**UNITED STATES  
ENVIRONMENTAL PROTECTION AGENCY**

**RESPONSE TO COMMENTS**

**US ECOLOGY, INC. SITE  
SHEFFIELD, ILLINOIS**

**OCTOBER 1990**

Figure 2

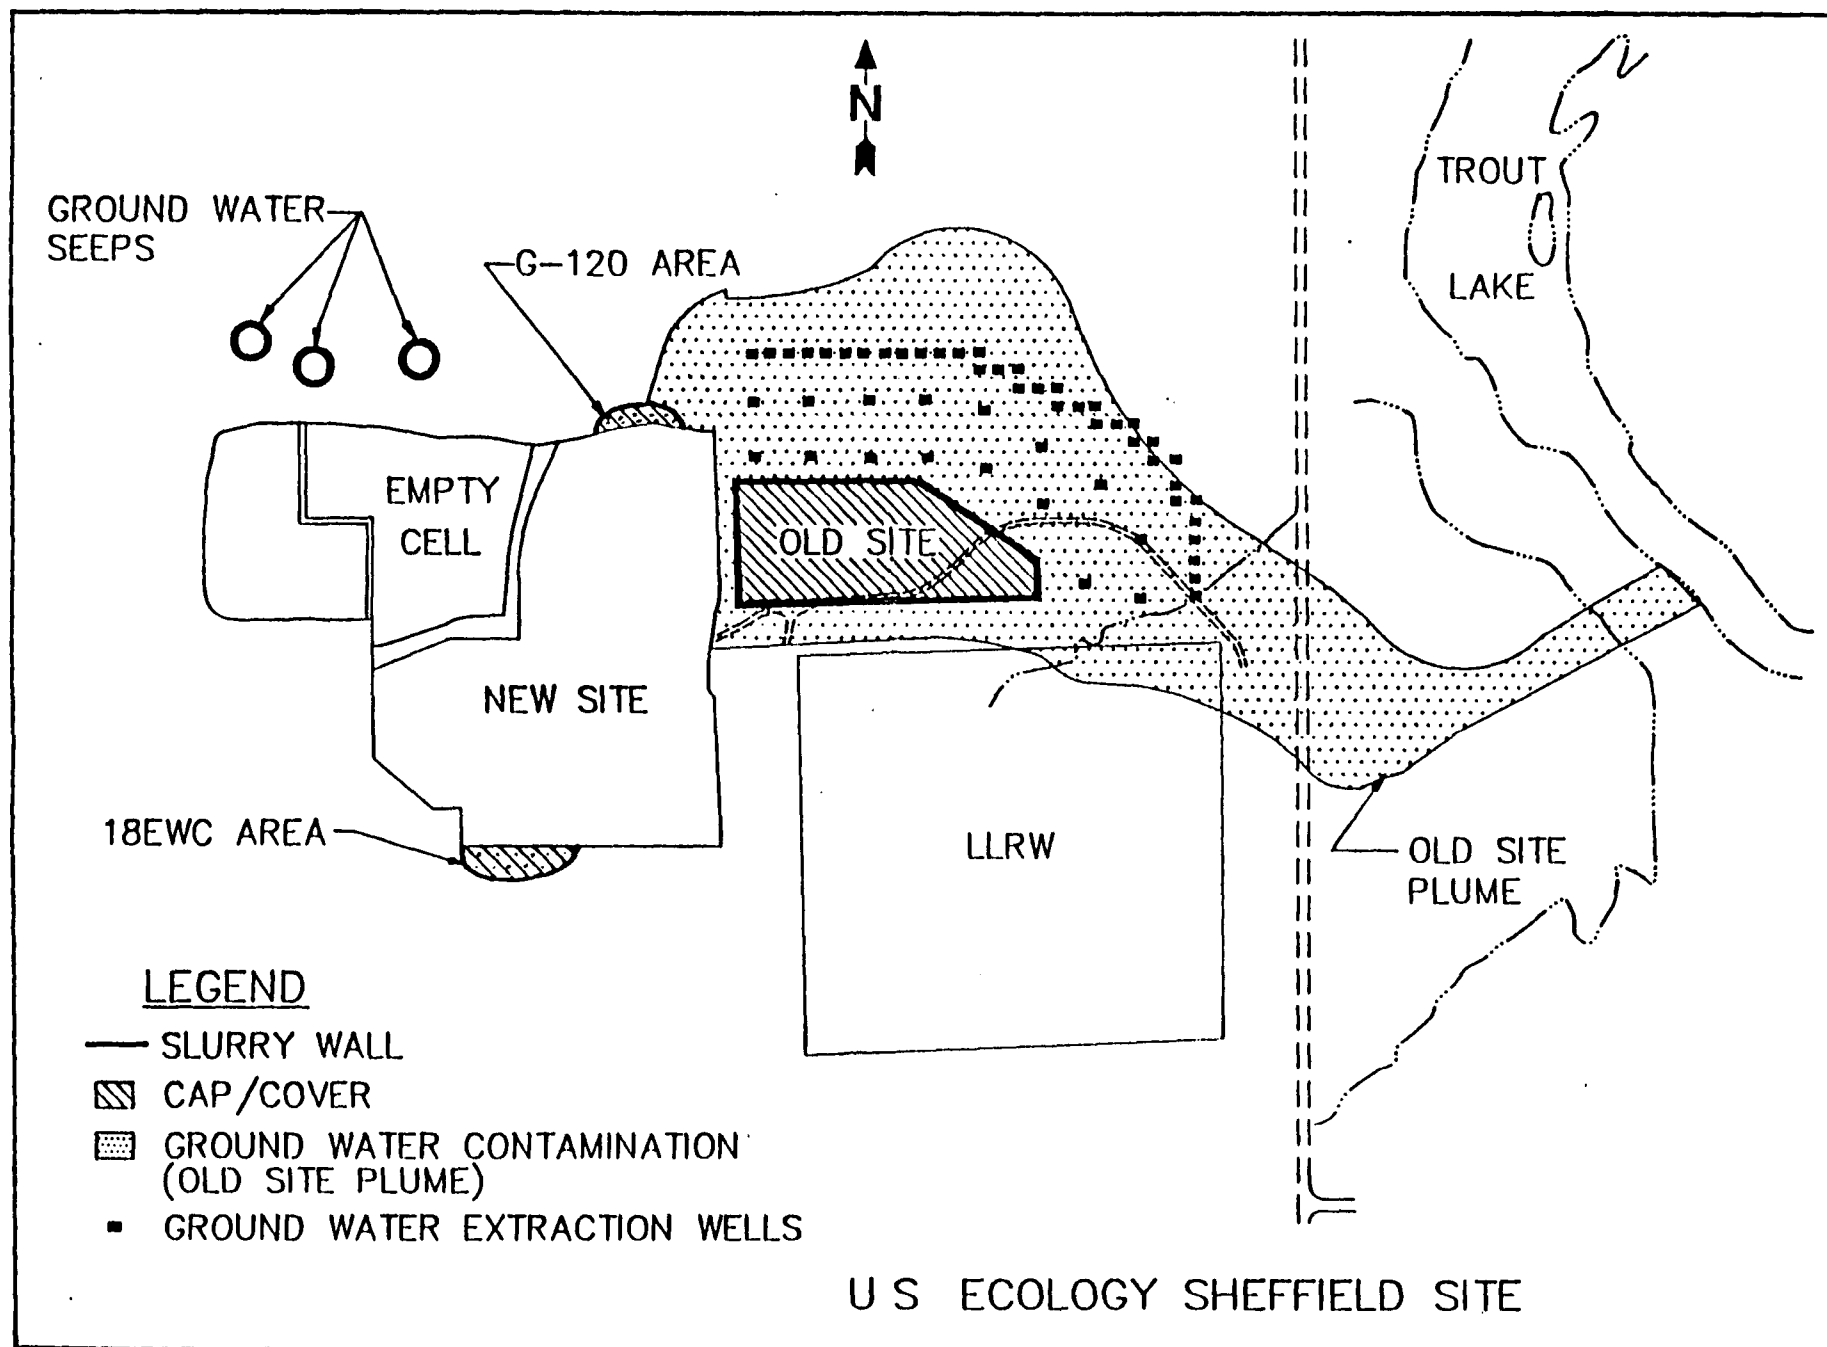
The selected corrective measures consists of two essential elements: (1) source control, and (2) ground-water remediation. These two elements are detailed below and depicted in Figure 2.
